Product Advisory

Product Family:	LS XGB PLC	Number:	PA-LSX-002
Part No.:	See table below	Date Issued:	08/01/2024
Subject:	Bus Coupler with Outputs malfunction in XG5000	Revision:	Original

Multiple Outputs turn on when setting the first one

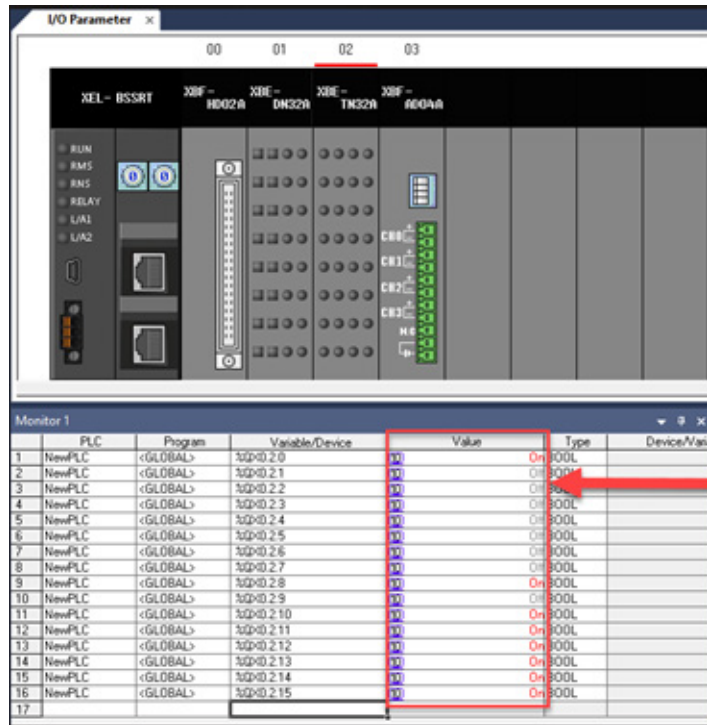
AutomationDirect has identified an issue when connecting the output modules listed above to an XEL-BSSRT bus coupler.

This issue only occurs when forcing/setting outputs through XG5000 software. When turning on an output while connected to the XEL-BSSRT with XG5000, multiple outputs will turn on. This happens when connected to the XEL-BSSRT over USB and Ethernet.

XEL-BSSRT firmware versions V2.20 and V2.40 have this issue.

LS Electric will provide firmware updates to address this problem.
